:NOTICE: Failure to acknowledge :	Solicitation No. DACW45 02 B 0007
:all amendments may cause rejec- :	
:tion of the bid. See FAR :	Date of Issue: 01 Mar 2002
:52.214-3 of Section 00100 :	Date of Opening: 20 May 2002

Amendment No. 0006
10 May 2002

SUBJECT: Amendment No. 0006 to Specifications and Drawings for Construction of
Wood River Flood Protection, Grand Island, NE
Solicitation No. DACW45 02 B 0007.

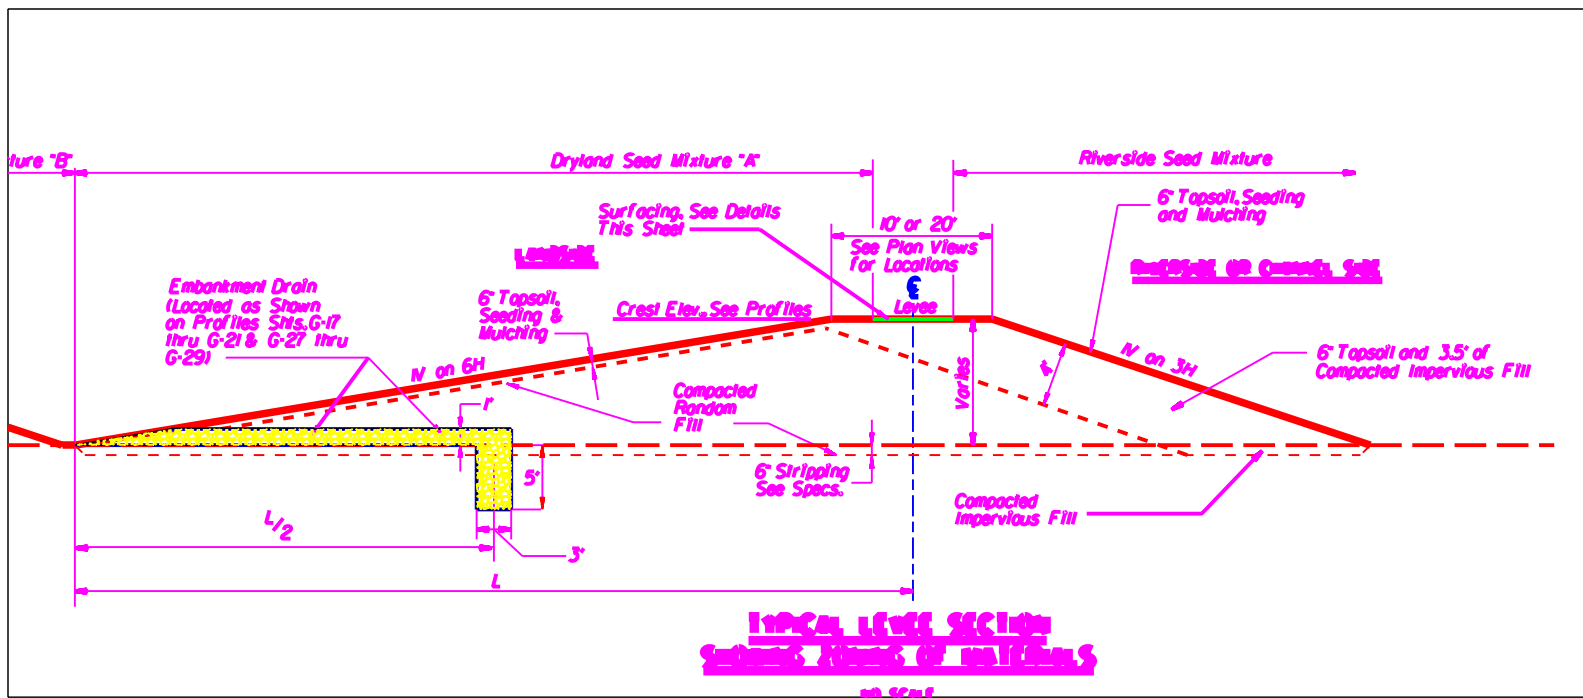
(6) Section 02212, add the attached cross sections showing typical levee section showing zoning of materials.
